Model No.: Unit Prefix; AEE, ASA, ATA, AYA, AEE-M, ASA-M, ERM, AXA, AET
Product Description: Industrial, Railway and Medical DCDC modules.

Reason(s) for Change: Branding Update to Advanced Energy and application of UKCA mark

Description of Change(s); Change of the module's branding from Astec or Artesyn Branding to Advanced Energy Branding
And the application of the relevant UKCA marking to the respective units

1 Brand per family Prefix

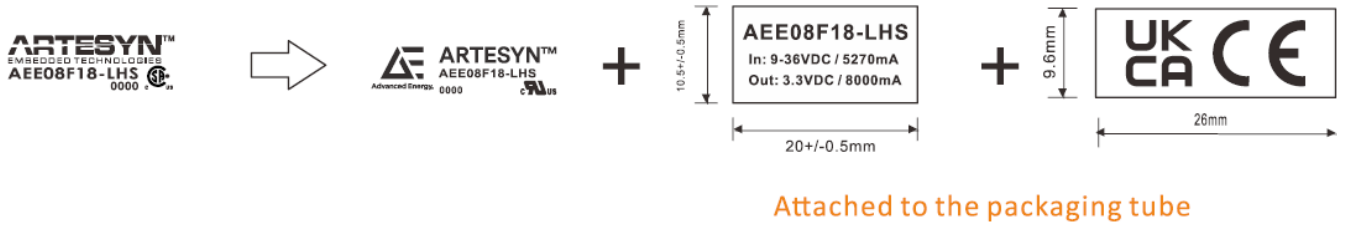
- AEE 40Watt** family
- AEE-50Watt** family
- AEE-M**; Medical family
- ERM**; All families

Example of the change;

3 Brand per family Prefix

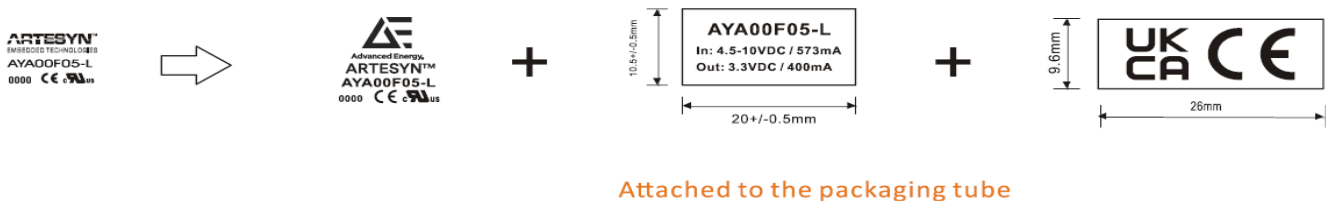
- AYA**; All families

Example of the change

7 Brand per family Prefix

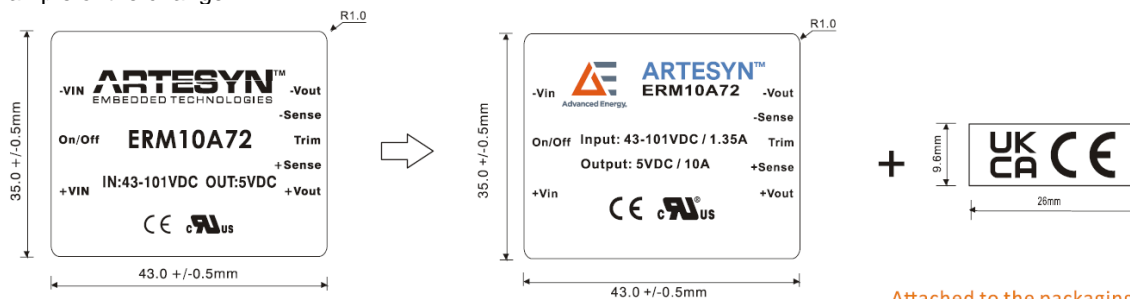
ERM10 family

Example of the change

Attached to the packaging tube
